RE: 2900-2990 W. Euclid Ave – PUD for Dental Office Building

P.C. #: 16 - 008 – Round #2

PLAN COMMISSION PC #16-008
Westgate Dental
2900-2990 W. Euclid Ave.
PUD for Dental Office Building
Round 2

Project: Westgate Dental
2900-2990 W. Euclid Avenue
PUD for Construction of Dental Office Building
P.C. # 16-008
Round 2

Fig. 35
Shower Size and Clearances

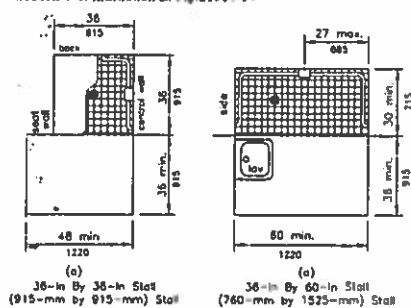
Sheet A1.2 – Private Restroom Petitioner's Comments in quotes and italics

"Restroom is accessible by removal of the shower."

"Our understanding is that this code applies to public and employee restrooms. This restroom is for private use only by one individual and will be keycard accessible only."

1. Staff Response: The configuration of the private restroom with built in shower lacks adequate wheelchair maneuvering space to access the shower unit and the toilet.
2. The shower unit itself is inaccessible per IAC 400.310(o)(B) and 400.Illustration B Figures 35(a) or (b).
